KILKENNY COUNTY COUNCIL
Comhairle Chontae Chill Chainnigh

Chief Executives Report on the Consultation process
for the proposed
for the restructuring and renovation of
The Tholsel (City Hall)
High Street, Kilkenny.

May 2019

Senior Planner's Report

Part 8 Scheme Drawing

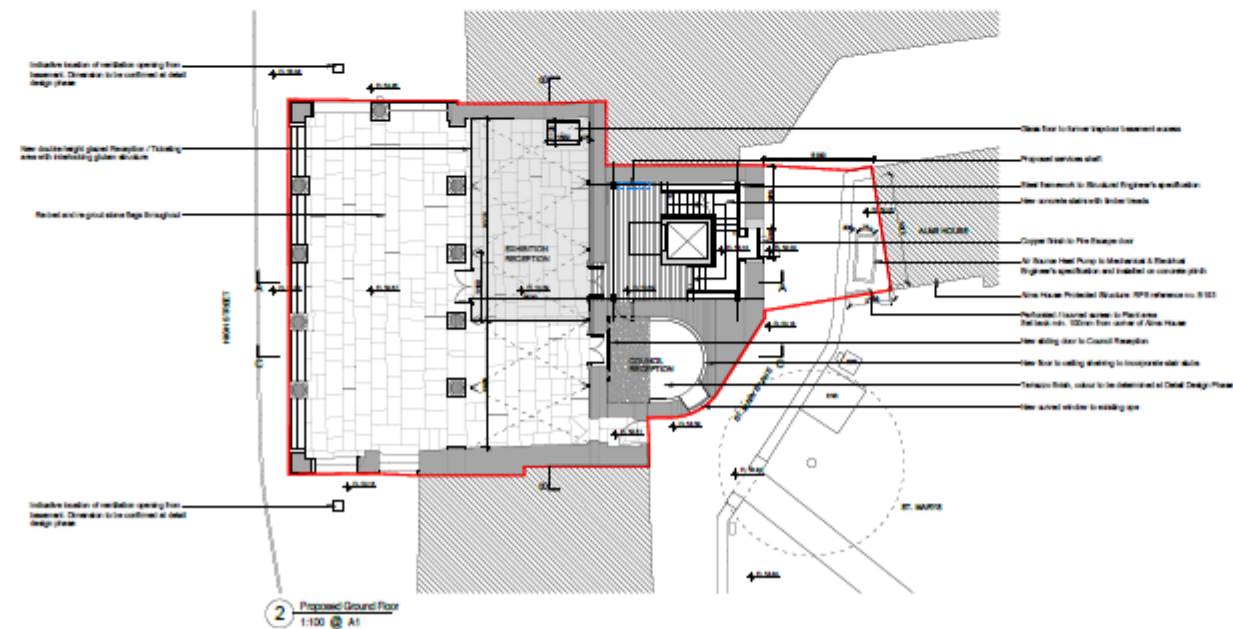
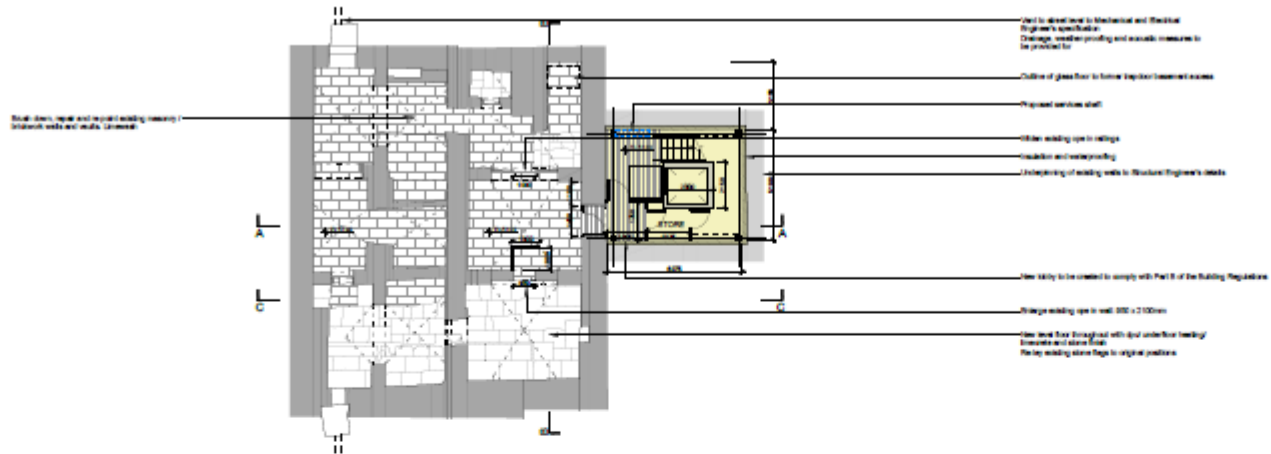
- The entrance into the glazed exhibition reception should be via double doors on the High Street front in order to preserve the sense of symmetry of the façade and the central axis of the plan. The Department suggests that an artistic treatment of the double doors, for instance acid-etched branding, may further enhance the sense of symmetry and central axis.

- Detailed drawings in respect of the modified east-facing opening in the proposed exhibition space/gallery should be submitted demonstrating the form and finish of the proposed window linings.

- The proposed works will require the removal of a mid twentieth-century terrazzo staircase contributing to the character of the protected structure. The existing terrazzo should be retained at ground floor level and an impression of the curved plan indicated by a floor finish of brass-framed wedges of similarly-coloured terrazzo following the treads of the staircase. Detailed drawings should be submitted demonstrating how evidence of the staircase will be incorporated into the proposed shelving per Section 7.1 of the Conservation Report.

- A new opening is to be formed at the junction of the staircase return and mayor's parlour. However, there are inconsistencies between Drawing P16-336K-RAU-00- ZZ-DR-A-31002 where a section of masonry between the opening and junction is absent and the visualisation on p.22 of the Architectural Design Statement where a section of masonry is present. The form of the proposed new opening should be assessed and finalised. A section of masonry should be retained in order to prevent a visually unsatisfactory junction.

- Detailed drawings for the proposed lift and lift shaft should be submitted. The proposal was presented as a pit-based platform lift requiring no external lift shaft at pre-planning but is described in the Mechanical and Engineering (M&E)

Report as requiring a permanent open vent. A vent is not included on Drawing P16-3336K-RAU-00-ZZ-DR-A-31005 or in the visualisation in the Architectural Design Statement. Any external lift shaft should be assessed for its potential impact on the character of the protected structure.

- Samples of the proposed slate recommended in Section 7.2 of the Conservation Report should be submitted.
- Detailed drawings and specifications for the proposed railings encircling the cupola should be submitted. The swan neck detail visible in archival photography should be investigated as it may have significance to the protected structure via a well-known local family as suggested by a similar swan neck detail present on a number of mural tablets in the adjacent Saint Mary's Church.

a) It is noted that a pre planning meeting took place on site with the architectural representatives from the DCHG and amendments were made to the draft design to take into consideration the views and comments of the DCHG.

b) The DCHG supports any considered proposals to adapt protected structures for reuse particularly when the objective is to provide a new or enhanced civic amenity. The DCHG accepts that the glulam framework may contribute to the architectural fabric but is seeking a detailed assessment which may inform revisions. This can be carried out before detail design is carried out. A Visual Impact Assessment of the proposed glulam structure is recommended to be undertaken and the details of any required revisions to glulam structure to be agreed with the DCHG.

f) This suggestion has been reviewed and unfortunately it will not be possible to change the orientation of the stairs due to the requirements for complying with the Building Regulations in respect of Fire and Accessibility.

i) The design of this wall will be revised to provide a more modern wall than the currently proposed partition wall. There may be issues with the suggested glazed wall due to the double height nature of the space. It should be noted that the Mayor's Office is a working office and some degree of privacy will be required. Details of the wall will be agreed with the DCHG.
